IN THE DRAWINGS**Re: Item #2 of the Office Action — Drawings**

PETITION FOR APPROVAL OF PROPOSED
DRAWING AMENDMENTS

Serial Number: 09/699,216
Appn. Filed: 27 Oct 2000
Applicant(s): Patrick H. Potega
Appn. Title: Apparatus for Enabling Multiple Modes of Operation
Among a Plurality of Devices
Examiner/GAU: Gail Verbitsky/2859
Mailed: 24 July 2002
At: West Hills, CA

Request for Approval of Proposed Drawing Amendment

FIG. 6

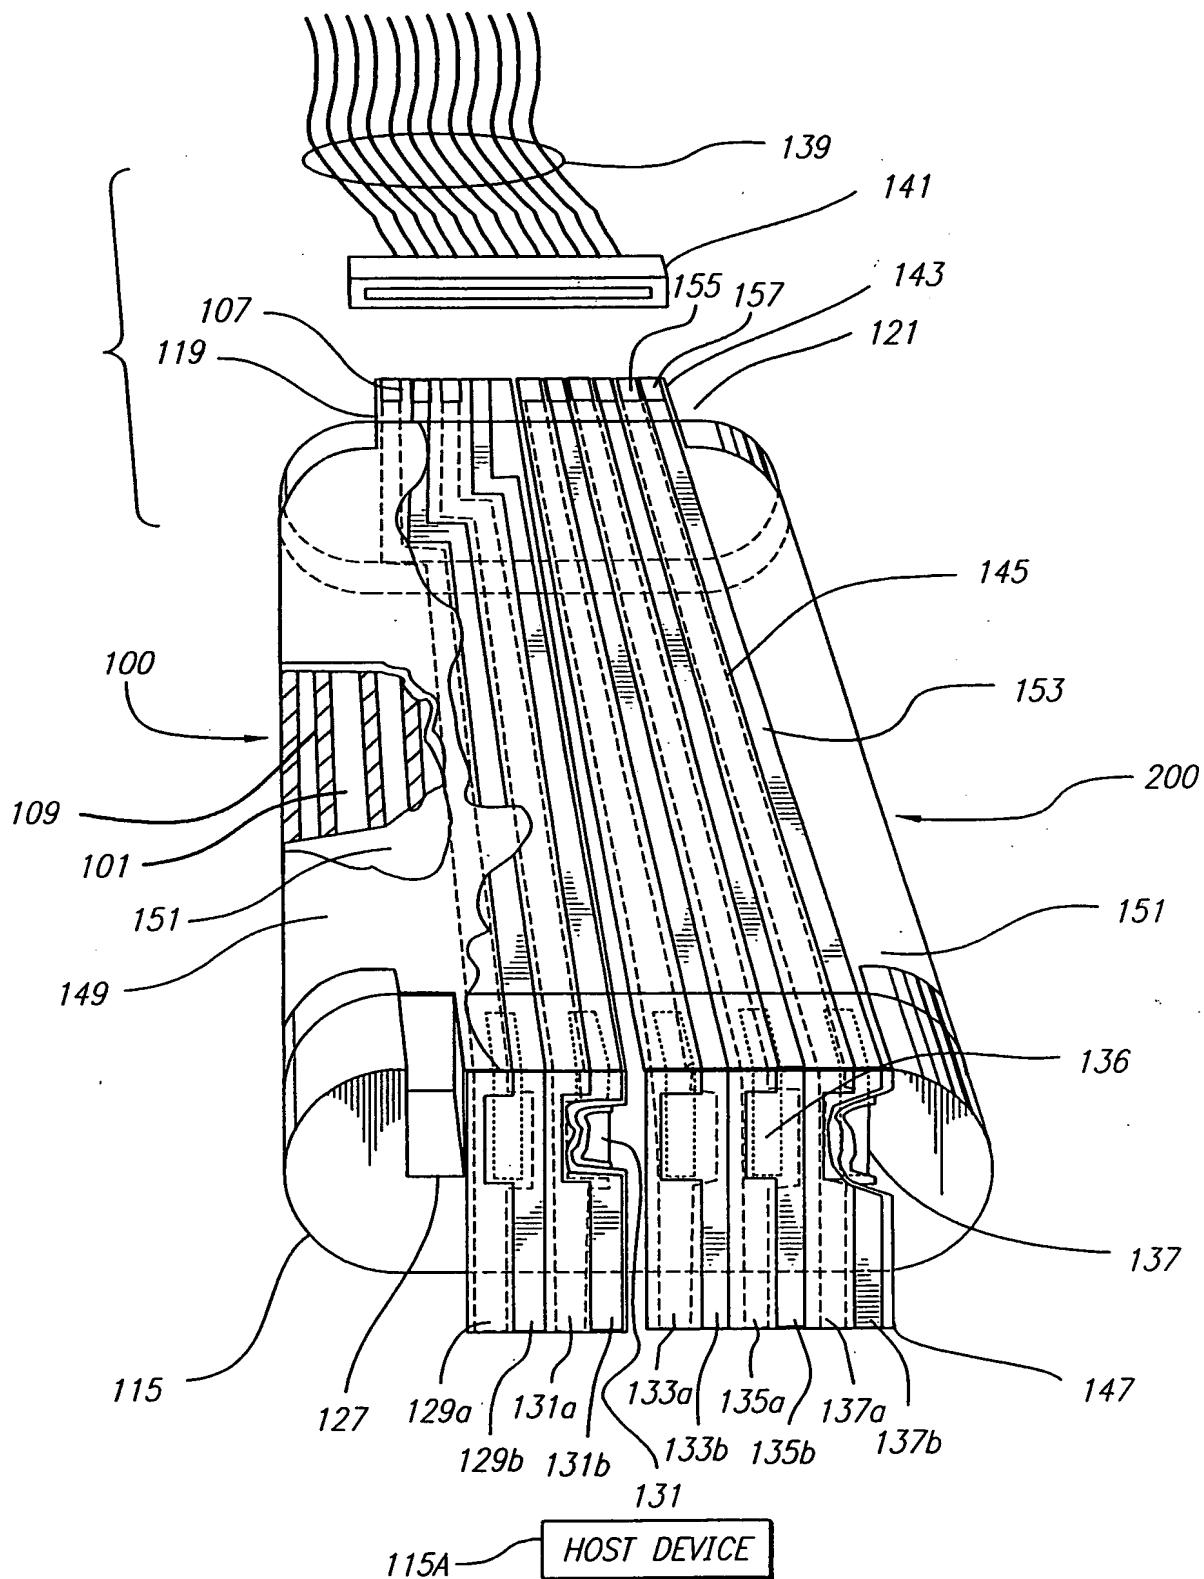
Related to this issue, the claimed "apparatus" according to claim 19. is comprised of a "multi-conductor interface member" and a "connection interface." The first of these elements may be implemented, for example, by the multi-layered construct 200 shown in Figure 6. The second of these two elements may be implemented, for example, by the connectors 141 and 143 in Figure 6, or by the jumpered connectors of Figures 7A-7D, or by the removable connector tab 163 in Figure 8A. Other claims bring in a resistive element, such as at 109 in Figure 6.
